# MIAMI BEACH

### Staff Report & Recommendation

### Design Review Board

SUBJECT: DRB17-0160  
**1420 Bay Road—The Grand Flamingo**

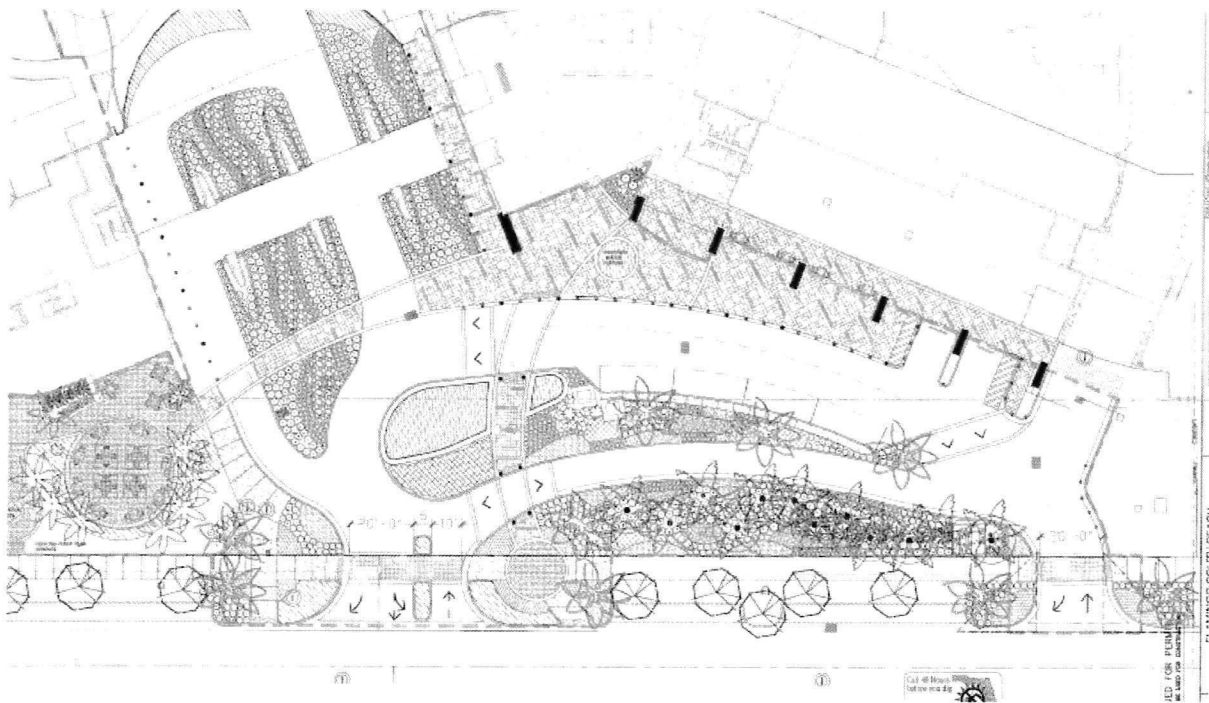
Traffic conflicts and circulation problems unquestionably exist at this development's front entrance location along Bay Road. Partially due to the built environment and prior building permits, and partially due to stringent access enforcement at the gatehouse at the direction of the Flamingo management. Concerns over security issues that has arisen from the residential development with over 1,680 apartment units with multiple points of entry and serious traffic flow disruption has led to an escalating enforcement of entry and access into what was once the primary, vehicular motorcourt to two, densely populated towers. The approval of the 35-story addition in 1997, also contemplated the vehicular flow "through and around" the central oval motorcourt. The traffic conflicts and circulation problems began after the completion of the central tower, and have only escalated with the advent of ride-sharing services and further dependency on instant delivery of goods. Ride-sharing and/or taxi waiting areas simply were not contemplated at the time of completion. After numerous meetings over the years with many City representatives from various departments including Planning, Parking, Public Works, Police and Transportation, as well as with concerned and affected neighbors, short term solutions have been tested, including on-street taxi cueing areas, onsite traffic police guards, and the introduction of pavement striping and bollards in an effort to resolve the fundamental issue of cueing and back-up onto Bay Road.

Approved site plan October 2007 DRB File No. 20925

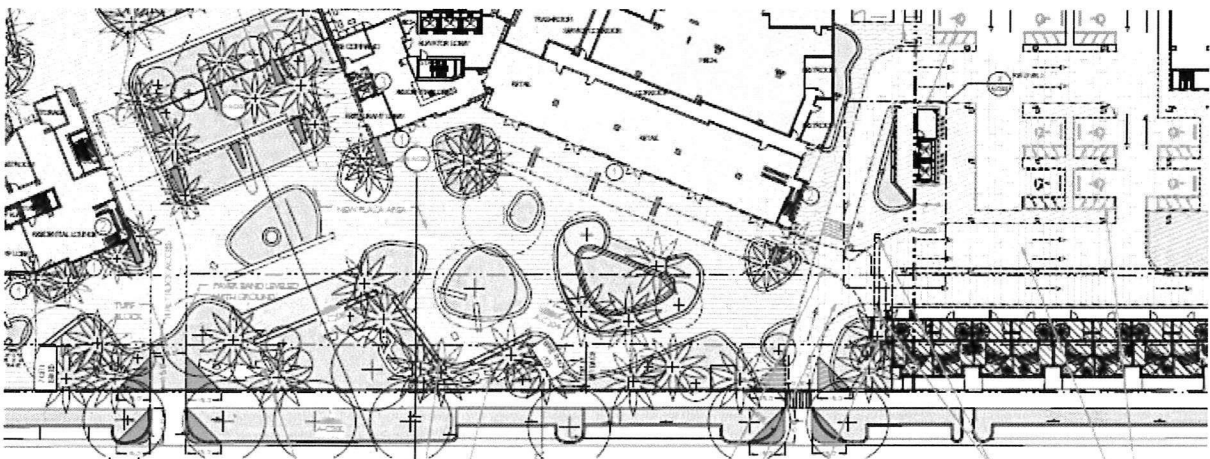
While the 2017 site pan is the scheme preferred by the Planning Department, the applicant does not wish to revisit a plan that, according to them, fundamentally does not work to improve pedestrian safety, eliminate traffic cue and work in tandem with the concept for site improvements. The applicant has stated on numerous occasions that this scheme does not work from a transportation and traffic standpoint. Further, the submitted traffic report states that “as a result of the documented deficiencies of the 2007 site plan, it is not recommended to implement the circulation plan presented in the 2007 site plan”. Staff would note the the same traffic engineer company that cites the deficiencies of the plan is the same engineer that designed the 2007 plan. Regardless, the proposed application herein features a stacking capacity for 19 vehicles in the North Tower and 6 vehicles in the South open air area and removes the curb cut gape that prevails along Bay Road and currently negatively impacts the pedestrian experience along Bay Road.

While staff continues to have some reservations with the impact the proposed new curb cut and overall elimination of the central vehicular entry drive, the applicant maintains that the proposed dual inbound and outbound traffic configurations for each new entry/exit drive and ride sharing valet operations has some tangible benefits with regard to internal and external

1 | Central Tower - West Elevation | Existing  
 SCALE 1/8" = 1'-0"

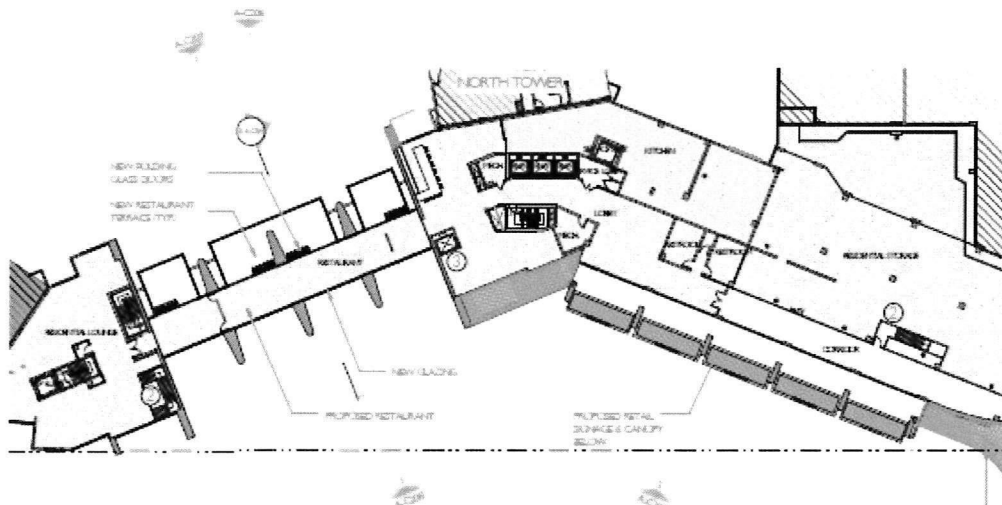
maximize the views and enhance the space, the applicant is also proposing a new glass storefront window system that will expand upwards approximately 25'-0" to the bottom of the central tower as well as changing the western fixed glass system with an operable 'nana' wall system that will provide access onto new elevated seating balconies. The 1997 DRB approval for the tower addition noted that: [the tower] is sited parallel to 15<sup>th</sup> Street and is slightly arced in plan concave fashion to work in conjunction with a semi-circular arrival plaza. [And] an approximately 4,800 SF (120'x40') hole will be located at the base of the proposed tower, at the first level, in order to provide a view corridor to the bay at the western terminus of 15<sup>th</sup> Street.

Staff maintains the blocking of the view corridor violates that original approval. Further, plans submitted as part of this application depict an 180 seat restaurant above the ground floor. Sec. 142-902(2) of the City Code allows for residential buildings in the RM-3 zoning district to contain accessory uses that include retail or a 30 seat café on the amenity level and open to residents and their guests only.

As such, the proposed 180 seat restaurant on the higher floor that is open to the public is not a permitted use. Aside from this pressing zoning concern, the blocking of the view corridor is antithetical and contrary to the original approval of the 35-story addition of the central tower. Staff strongly recommends denial of this portion of the application and would require that the existing elevated skybridge remain unchanged in its dimensions and height.

- a. The architect shall redesign the second floor central restaurant/lounge area to comply with Section 142-902(2)e.2. The proposed restaurant located on the amenity level of the Center Tower shall be restricted to patrons and seat count pursuant to Section 142-902(2)e.2., as may be amended from time to time.
